### **ITEM FOR ENVIRONMENTAL COMMISSION AGENDA**

<b>COMMISSION MEETING DATE:</b>	April 20, 2022
<b>NAME &amp; NUMBER OF PROJECT:</b>	Dalfen Industrial SP-2020-0407D
<b>NAME OF APPLICANT OR ORGANIZATION:</b>	Hollis Scheffler Pacheco Koch Consulting Engineers, Inc
<b>LOCATION:</b>	6106 Ross Rd, Del Valle, TX 78617,
<b>COUNCIL DISTRICT:</b>	NA
<b>ENVIRONMENTAL REVIEW STAFF:</b>	Pamela Abee-Taulli, Environmental Program Coordinator, Development Services Department, 512.974.1879, <a href="mailto:pamela.abee-taulli@austintexas.gov">pamela.abee-taulli@austintexas.gov</a>
<b>WATERSHED:</b>	Onion Creek Watershed, Suburban Classification, Desired Development Zone
<b>REQUEST:</b>	Variance requests are as follows: <ol style="list-style-type: none"><li>1. Request to vary from LDC 25-8-341 to allow cut to 17 feet.</li><li>2. Request to vary from LDC 25-8-342 to allow fill to 18 feet.</li><li>3. Request to vary from LDC 25-8-301 to allow construction of a driveway on a slope with a gradient exceeding 15 percent.</li></ol>

Project Name:	Dalfen Industrial
Ordinance Standard:	Watershed Protection Ordinance
Variance Request:	Request to vary from LDC 25-8-341 to allow cut to 17 feet.

DALFEN INDUSTRIAL  
6106 ROSS ROAD  
CITY OF AUSTIN ETJ, TRAVIS COUNTY, TEXAS  
SITE CUT-FILL EXHIBIT

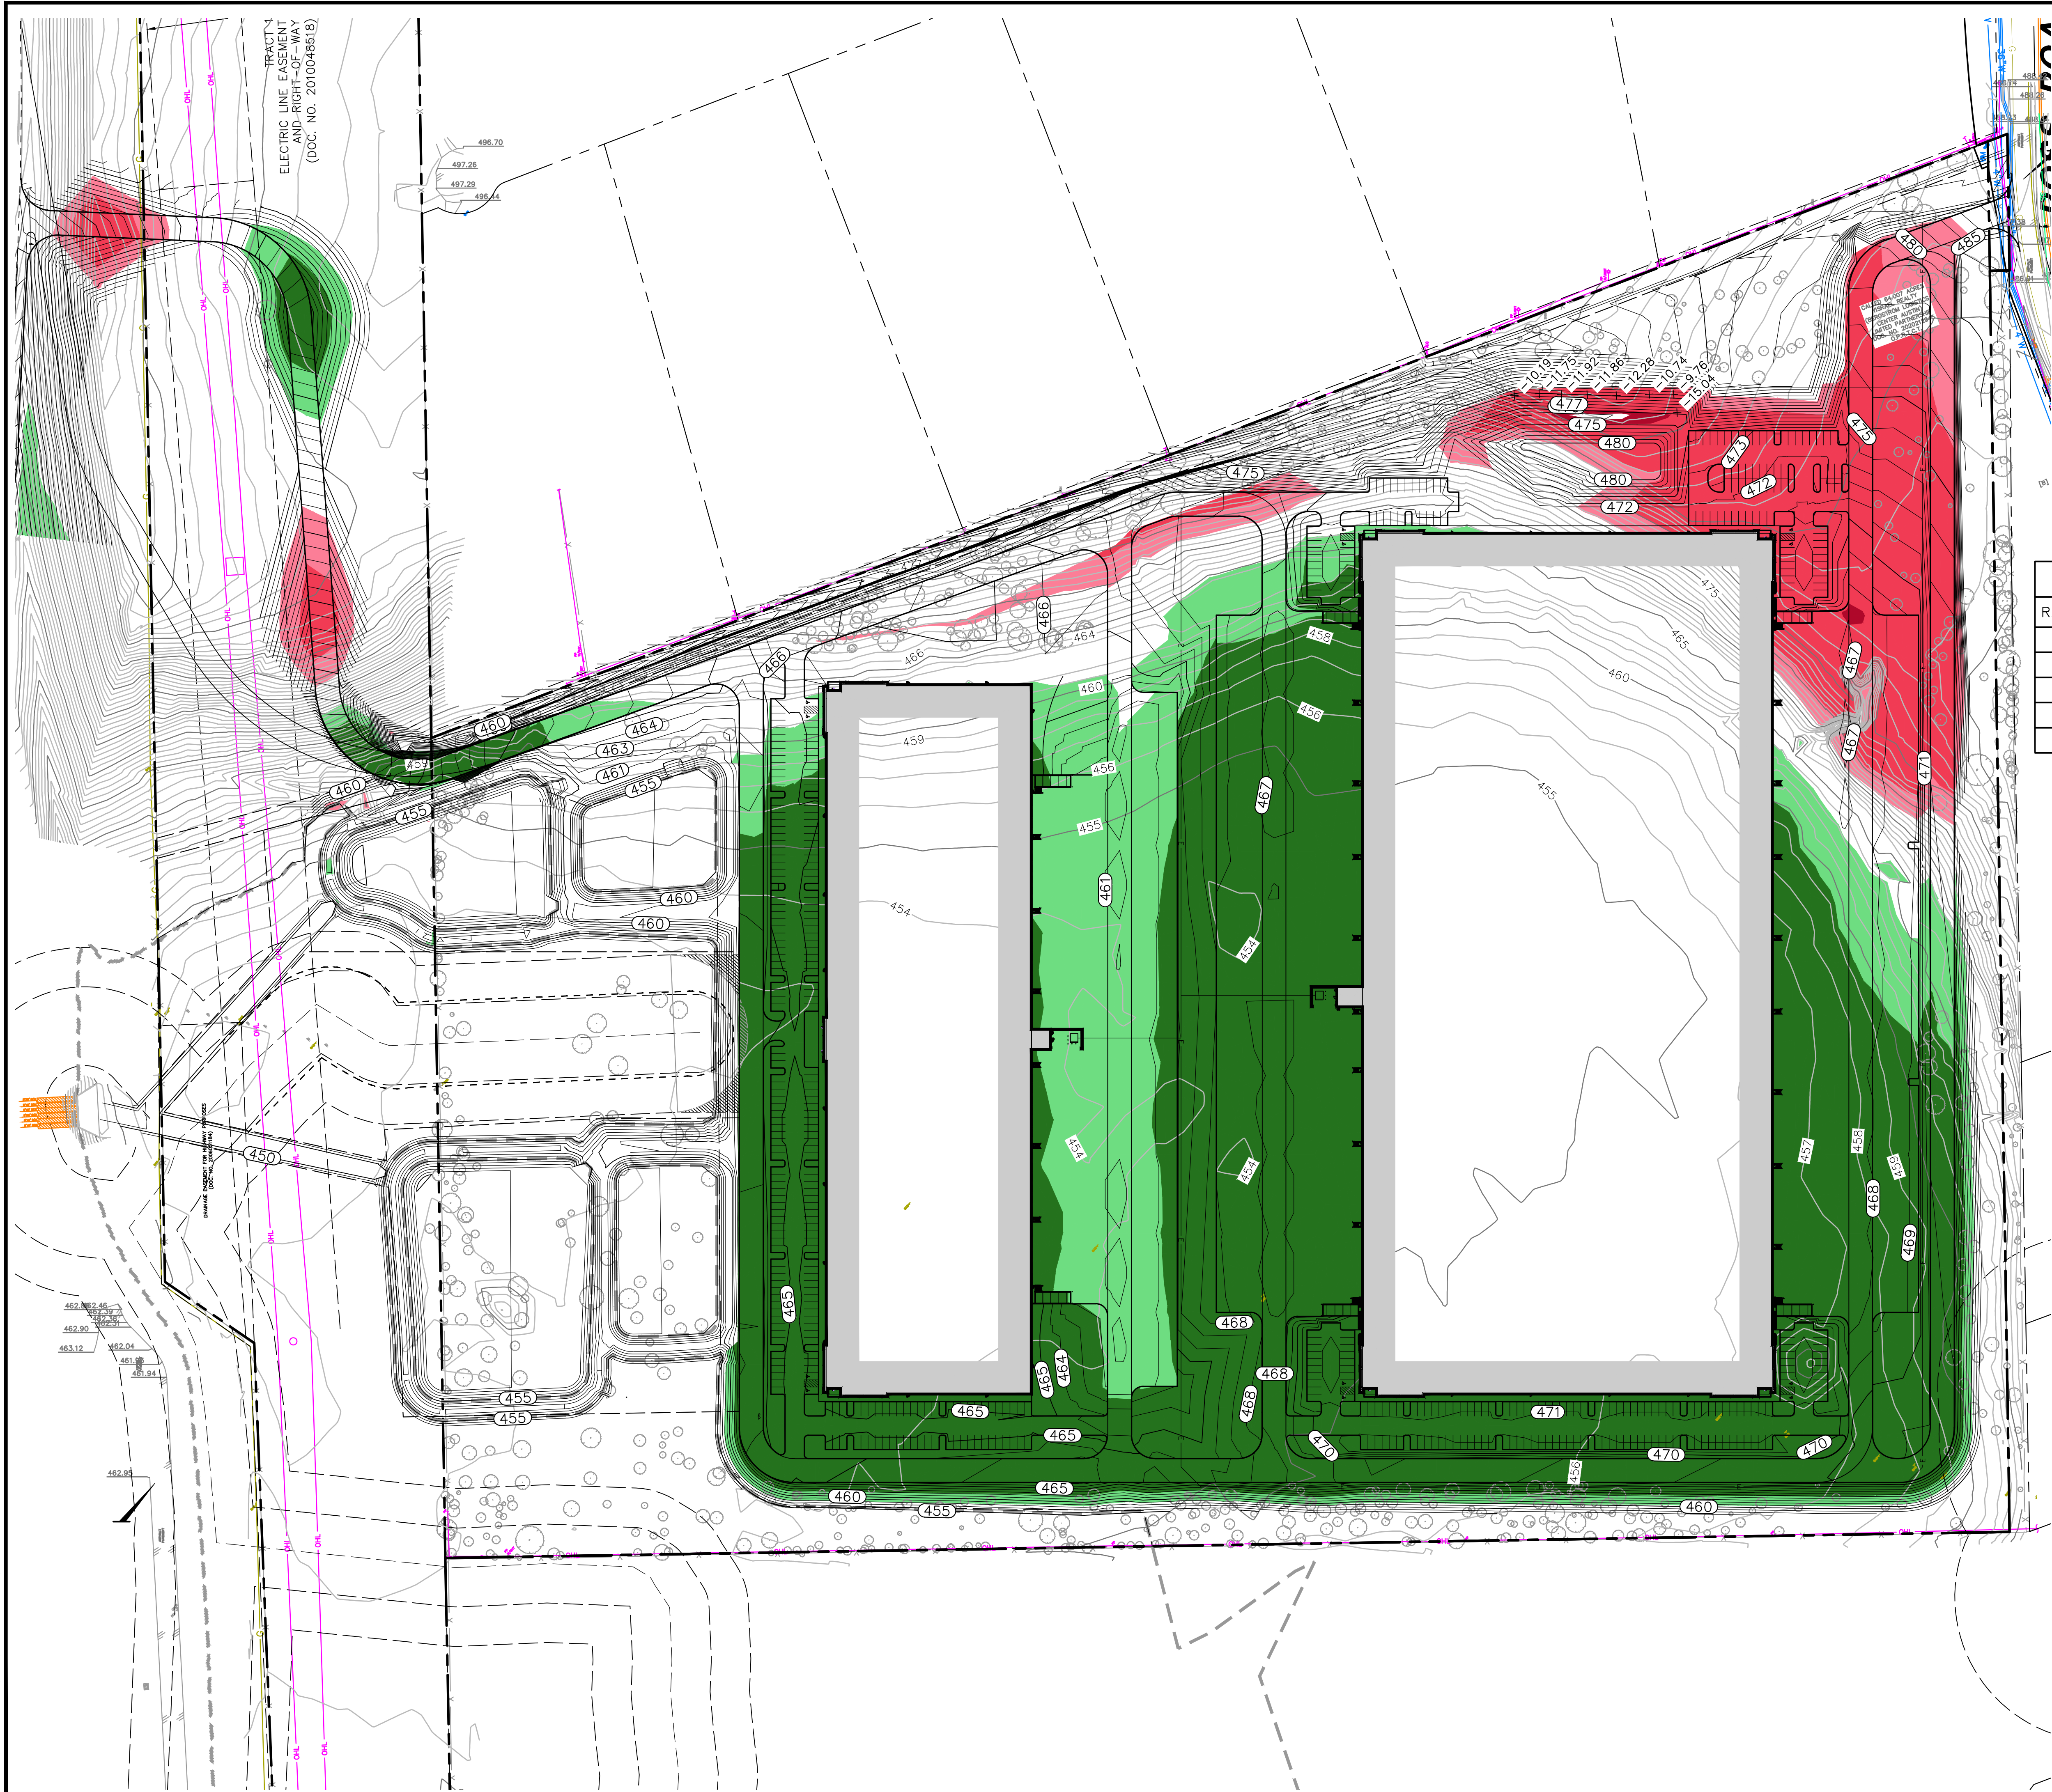
Yes Similarly situated properties with similar development type and subject to the same code requirements have received variances for grading in excess of four feet. These developments are all large warehouses located on relatively flat sites in the Desired Development Zone. Grading over four feet is necessary to create level finished-floor elevations and level loading docks and to maintain drives at minimal grades for maneuverability.

Yes The building placement on the property was constrained by the location of approximately 6.9 acres of critical water quality zone, lot configuration, existing topography, and roadway connectivity. Working around these considerations dictated the buildable area for the footprint of the two buildings.

The development layout was also shaped by the elevation of an existing headwall located in an easement northwest of the site. The headwall consists of five 5'x 6' box culverts to which the drainage of the site flows. The elevation of the headwall determined the elevation of the stormwater ponds, which in turn determined the building elevations.

<b>STAFF RECOMMENDATION:</b>	Staff recommends this variance, having determined the findings of fact to have been met.
<b>STAFF CONDITION:</b>	<ol style="list-style-type: none"><li>1. A landscape plan with native and adapted trees, shrubs, and grasses to be planted in the parking areas will be provided, even though a landscape plan is not required in the City's extra-territorial jurisdiction (ETJ).</li><li>2. A tree-shaded outdoor seating area will be provided to encourage employees to take breaks on-site, rather than driving to another location.</li><li>3. Trees outside of the limits of construction will be preserved, even though tree preservation is not required in the City's ETJ.</li><li>4. All cut and fill over 8 feet will be terraced or contained with engineered retaining walls.</li></ol>

1. A landscape plan with native and adapted trees, shrubs, and grasses to be planted in the parking areas will be provided, even though a landscape plan is not required in the City's extra-territorial jurisdiction (ETJ).
2. A tree-shaded outdoor seating area will be provided to encourage employees to take breaks on-site, rather than driving to another location.
3. Trees outside of the limits of construction will be preserved, even though tree preservation is not required in the City's ETJ.
4. All cut and fill over 8 feet will be terraced or contained with engineered retaining walls.

OVERALL SLOPE EXHIBIT

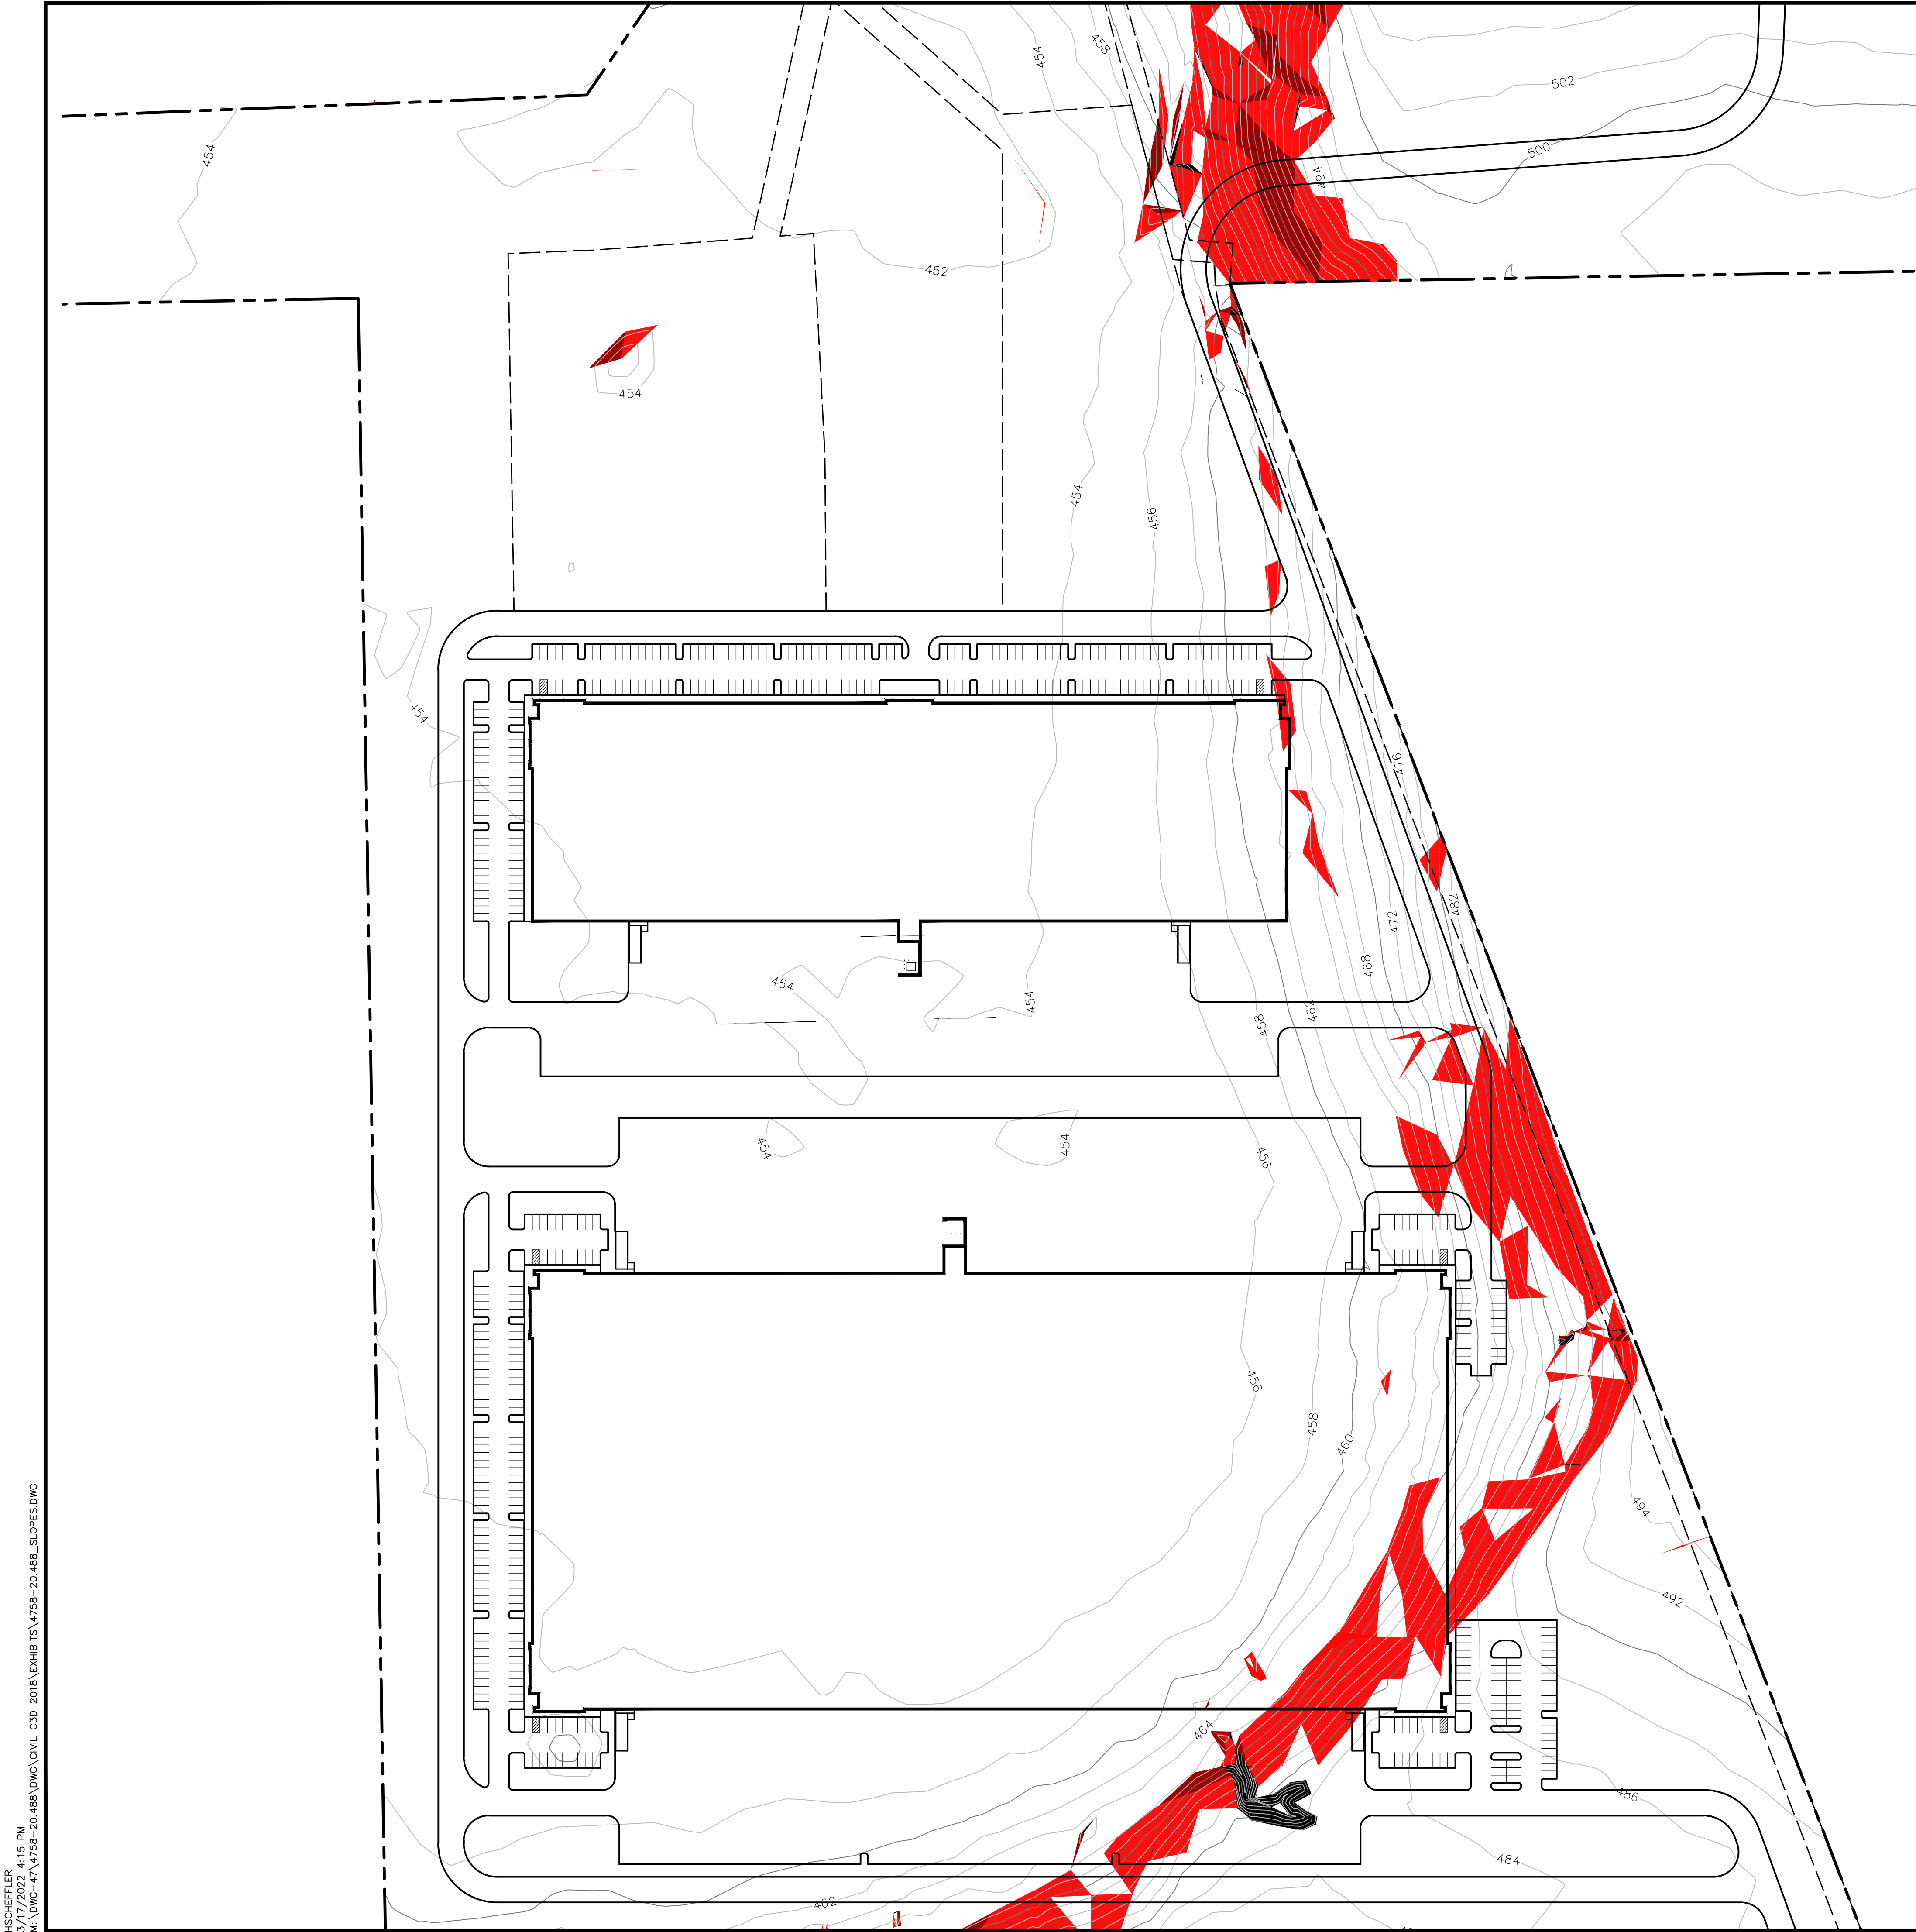
As seen in the overall slope exhibit, slope exhibit sheet 1 of 2, and slope exhibit sheet 2 of 2 there are areas of proposed construction for driveways, buildings, and parking areas that do not meet the requirements of sections § 25-8-301 and § 25-8-302.

Based on subsection A, item #1 of § 25-8-301 construction of driveways on existing slopes greater than 15 percent is allowed when the driveways provide primary access to a site that is at least two contiguous acres with a gradient of 15 percent or less. The overall area of this site is 91.82 acres, and as evident by the overall slope exhibit, the large majority, approximately 75.7 acres, has a slope of 15 percent or less.
